**CITY COUNCIL
REGULAR MEETING STAFF REPORT
AGENDA ITEM 7B**

TOPIC: Erickson Property

i. Consider 1st Reading of Ordinance No. 13-25 Rezoning
Property from R, Rural to R-2, Two Family Residential

ii. Consider Resolution No. 25-93 Approving Preliminary Plat

PRELIMINARY PLAT & SITE PLAN

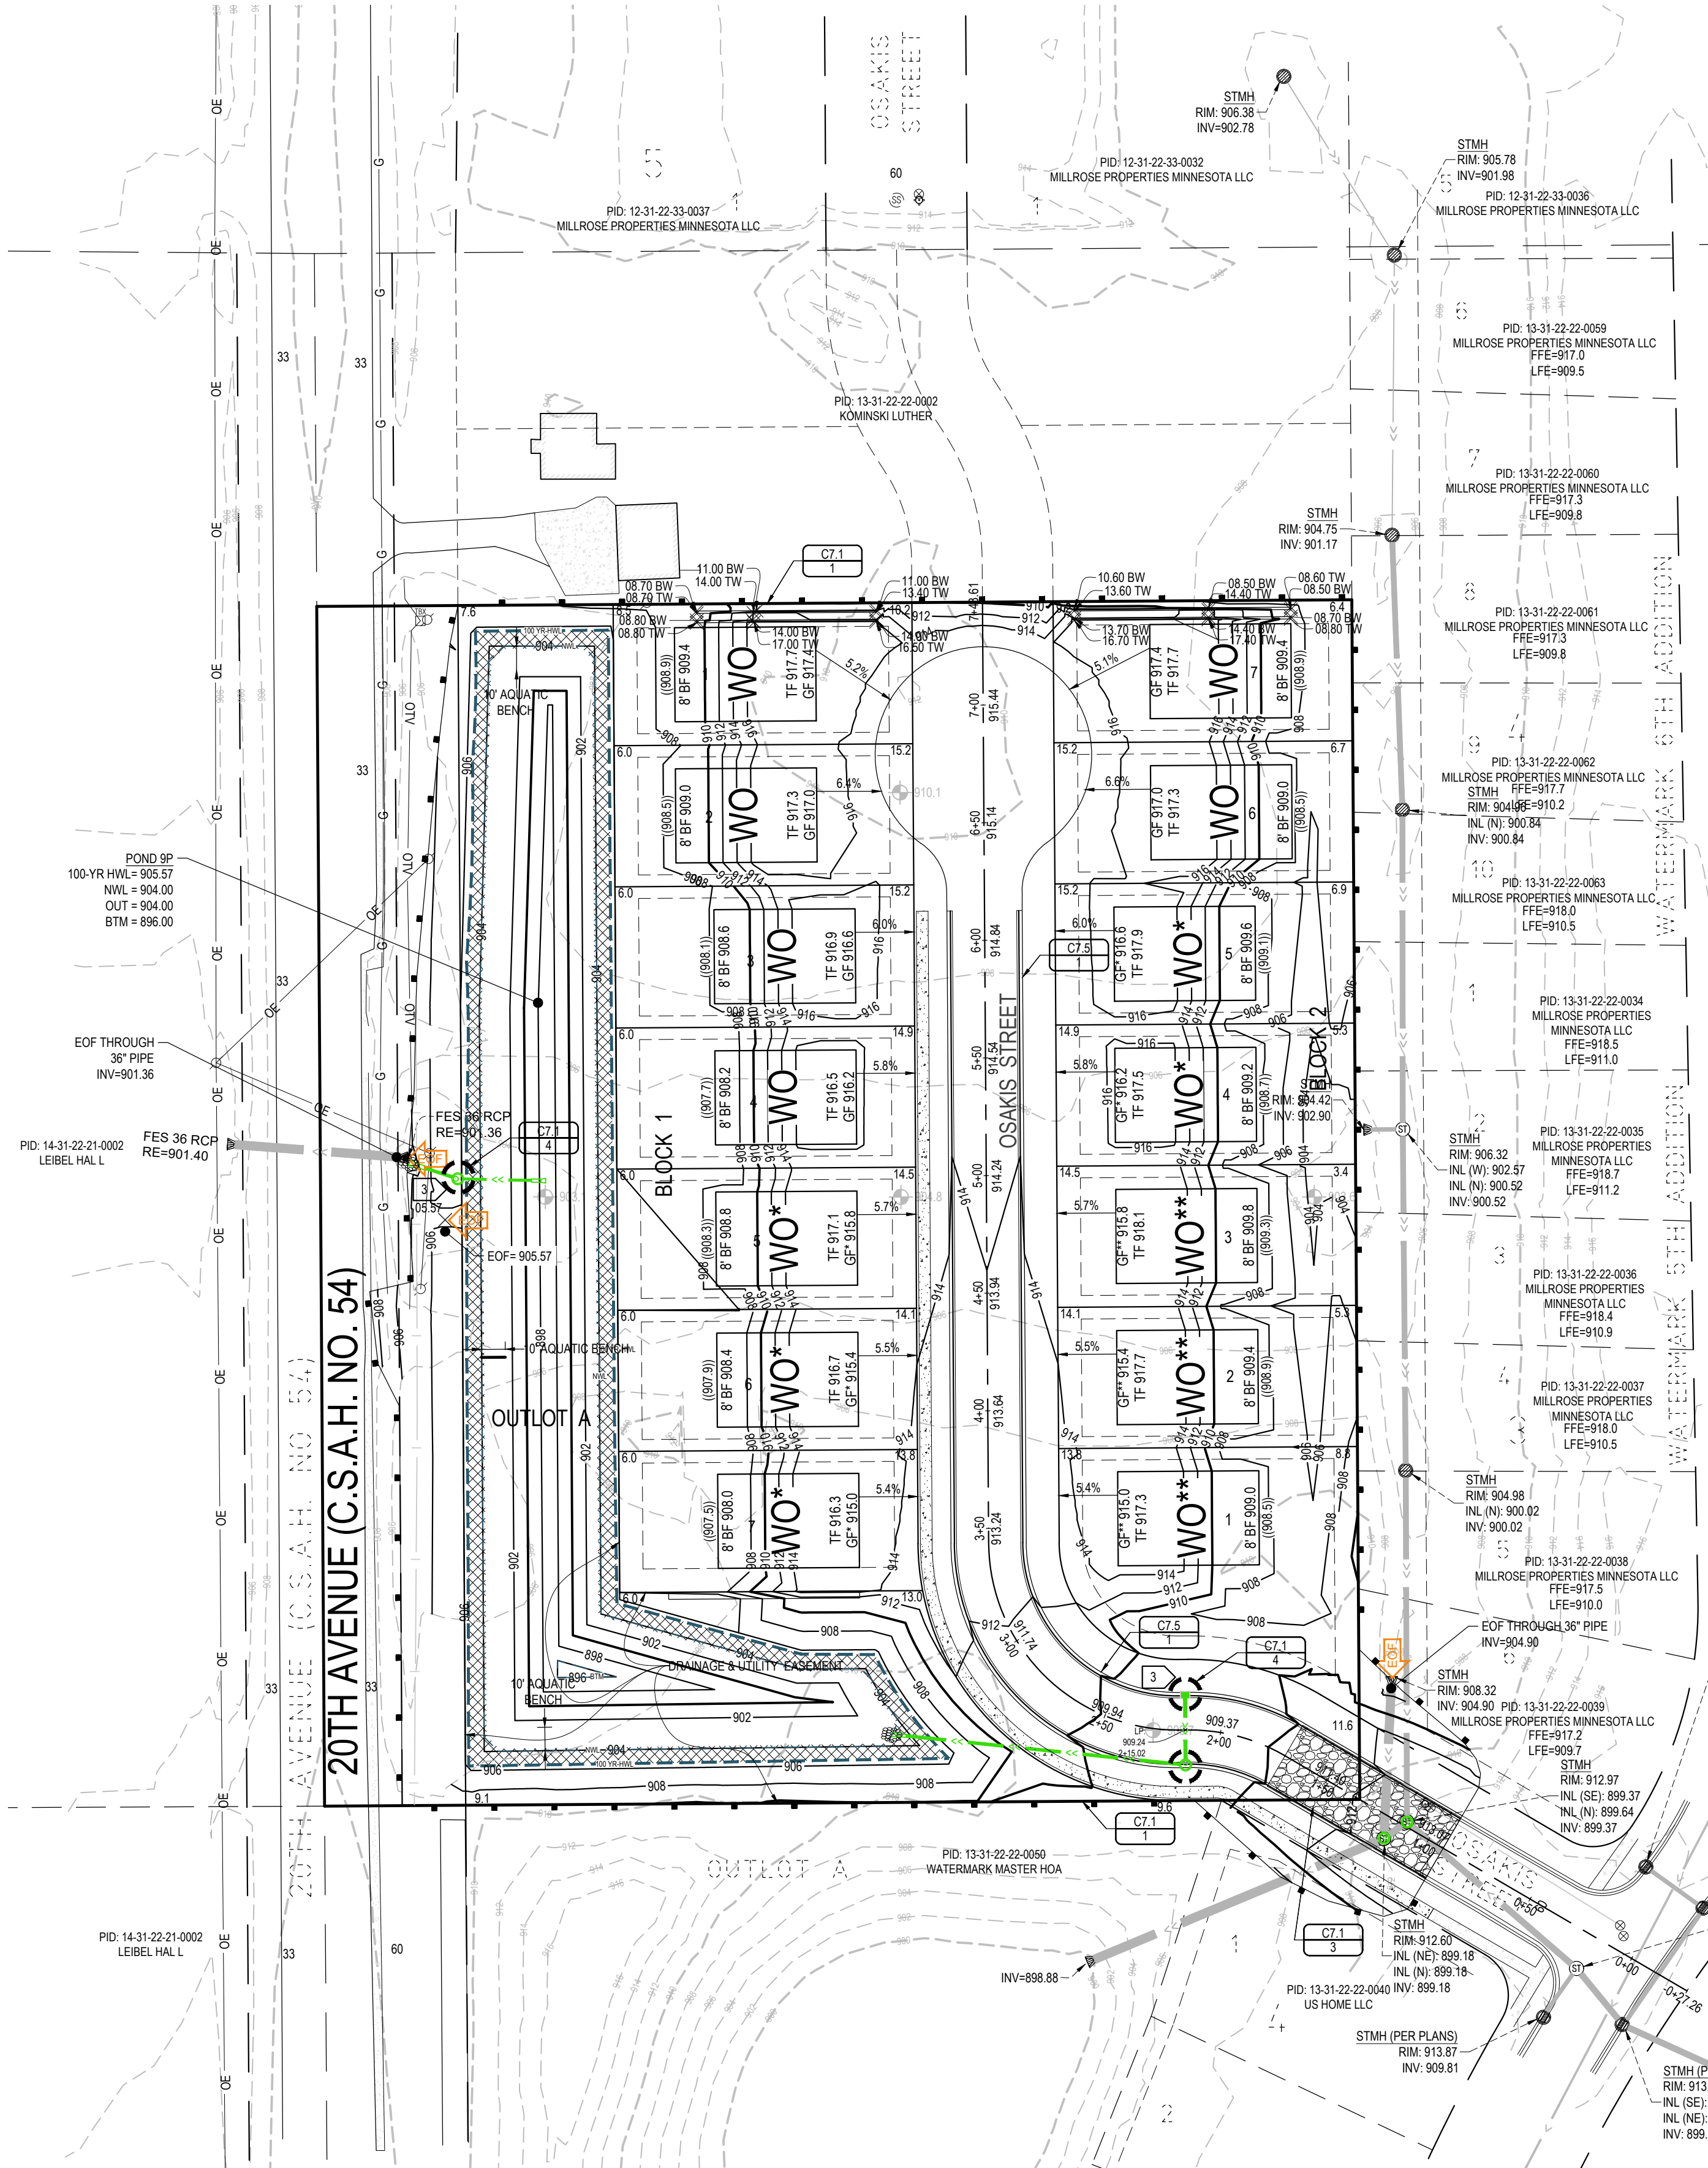
Double planted screening is being proposed with shrubs along the back of the property lines for block one as screening from 20th Ave. Screening should be provided on the property lines. Currently showing plantings within the outlot, this will likely cause maintenance issues in the future.

GRADING, DRAINAGE, PAVING & EROSION CONTROL PLAN

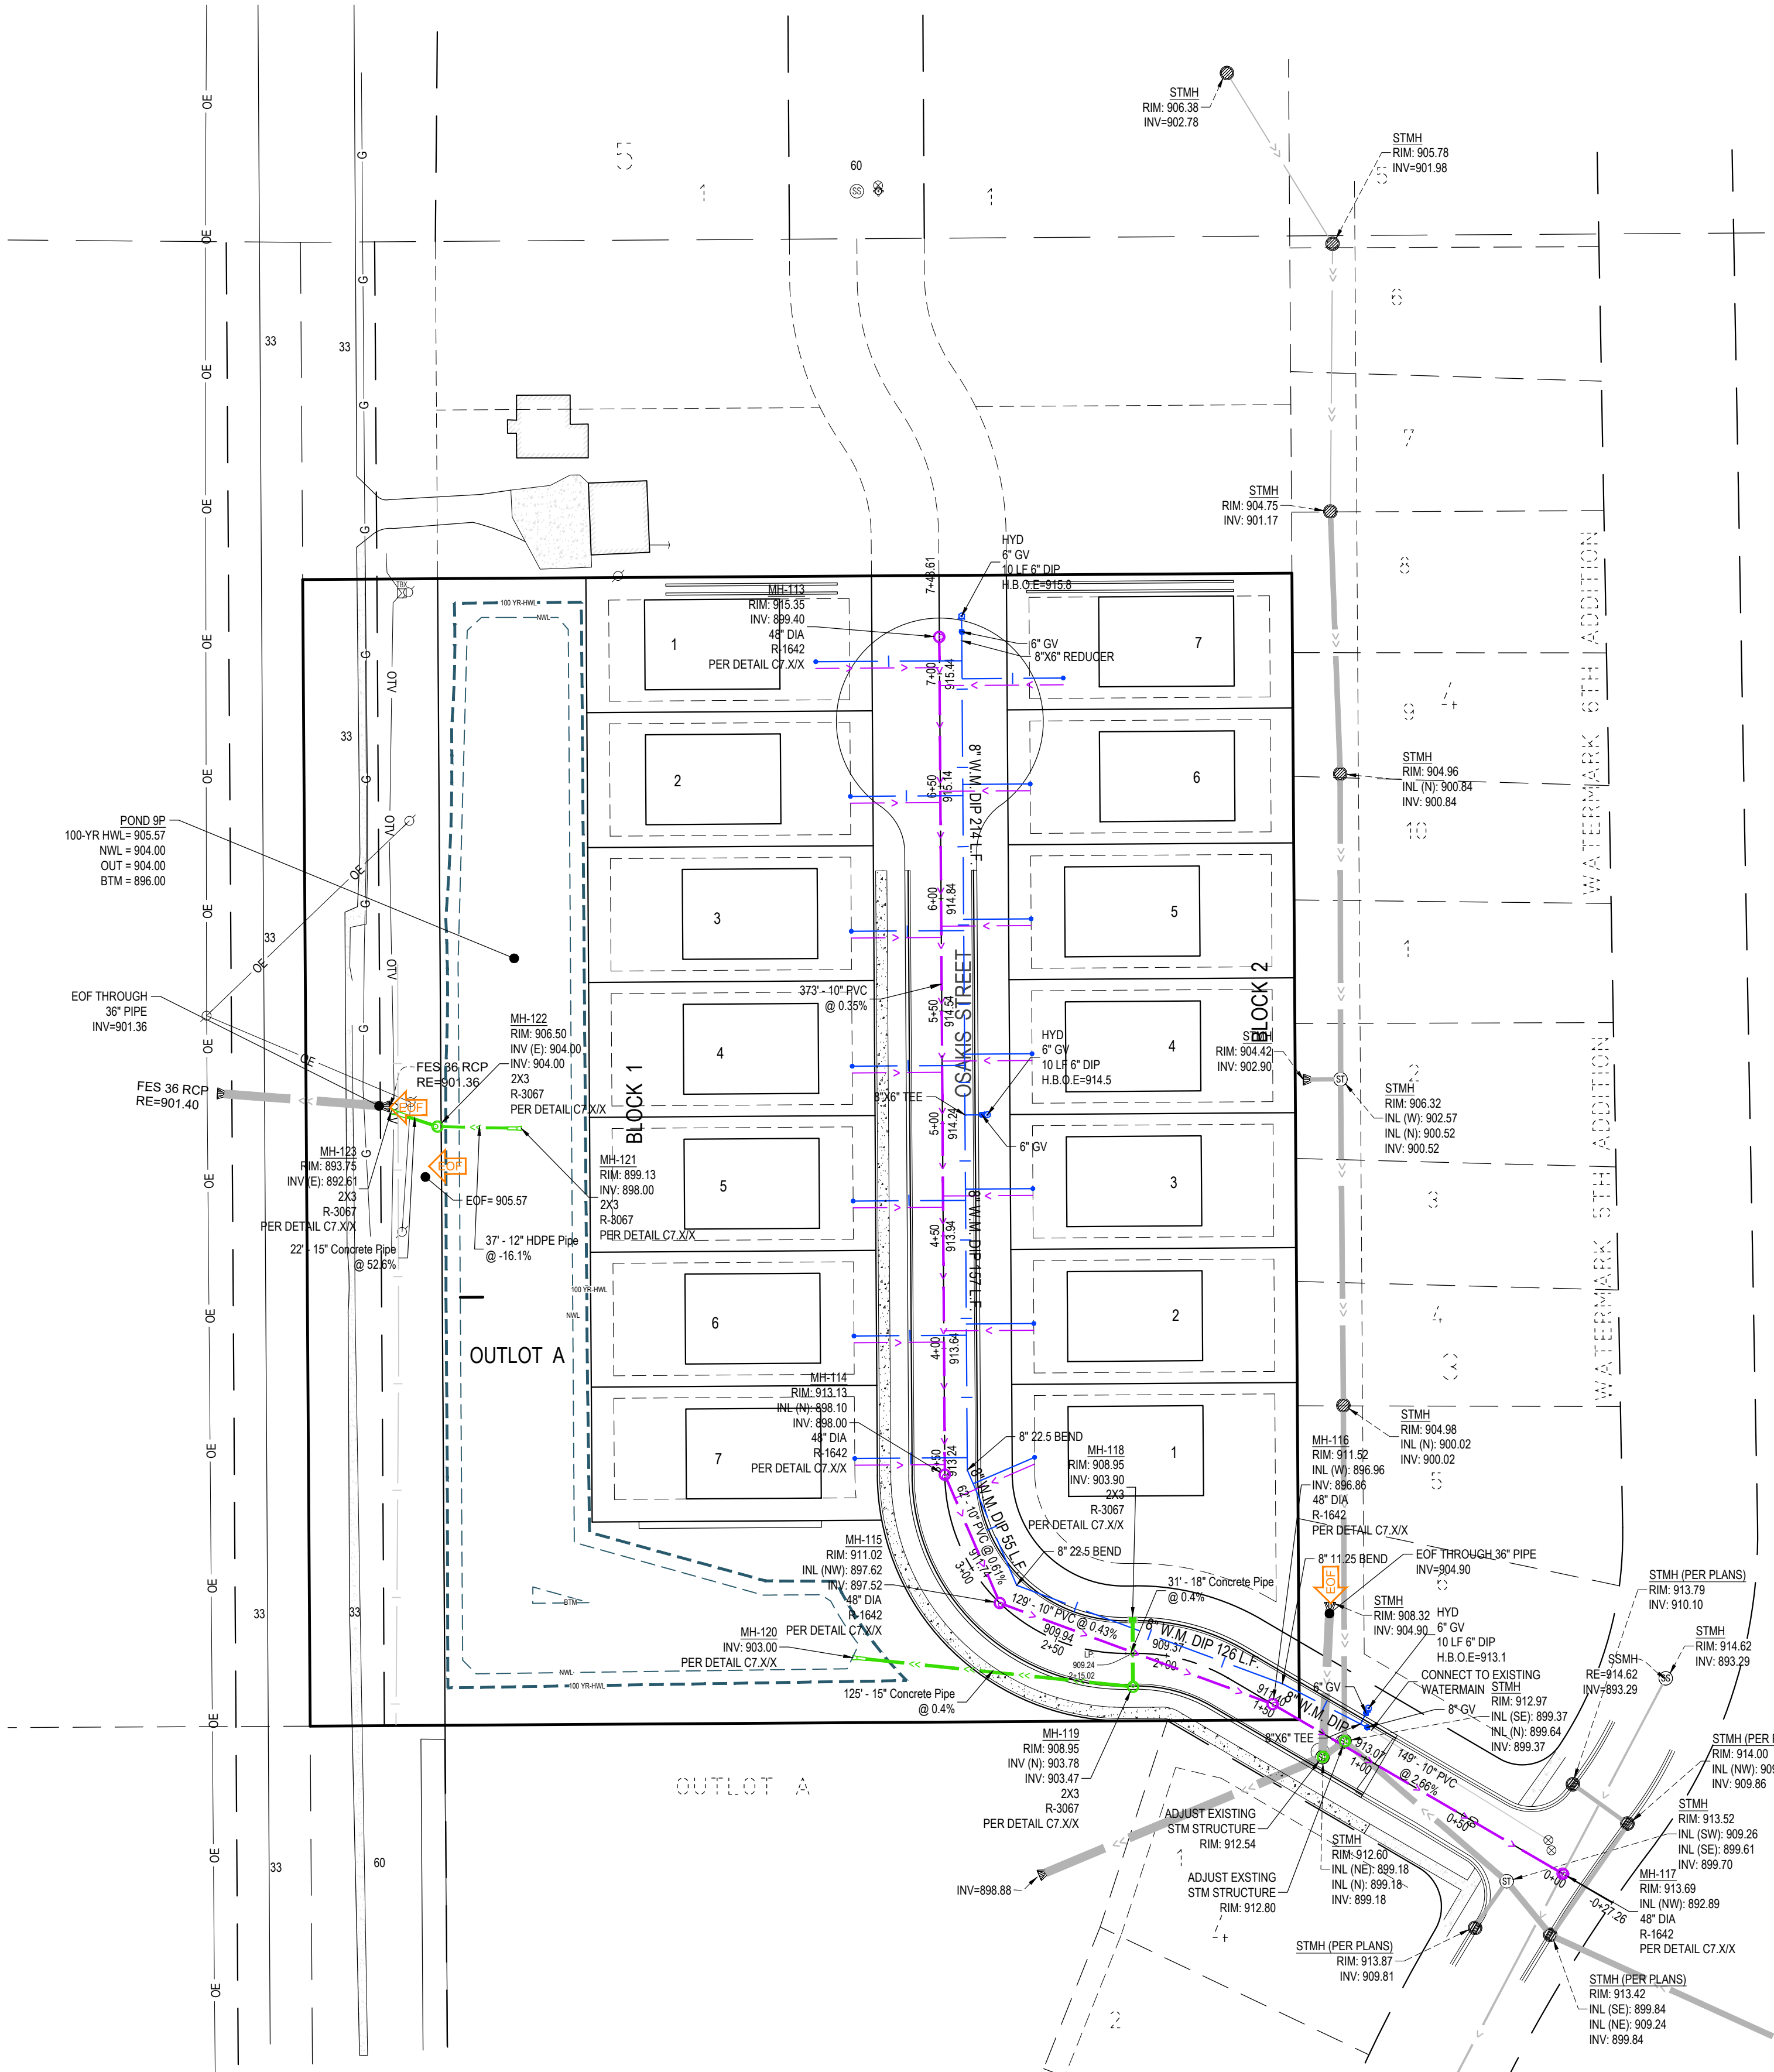
1. Provide EOF elevations, locations and routes for all low points in the paved and greenspaces.
2. Show all high and break points
3. Label all inlet elevations
4. Replace the eastern existing FES with CBMH and utilize the existing rear swales from Watermark 5th/6th (see redline comments) eliminating the proposed swale on the Erickson Property lots.
 - a. Consider removing FES and pipe and converting STMH to CBMH

- b. Minimum freeboard requirement between EOF and proposed/existing Lowest Opening Elevations (LOE) is 1'
 - c. Utilize current grading as-builts/plans for Watermark

- a. Further discussion regarding retaining wall location, ownership, and future maintenance will be required
 - b. Retaining walls exceeding 4' in height shall require a plan prepared by a Minnesota licensed structural engineer submitted for review and approval by the Building Official prior to permit issuance

- i. Provide fences for safety as required.
- 7. Driveways/Garages will need to be on the southern sides of the two most northern lots with the temporary cul de sac.
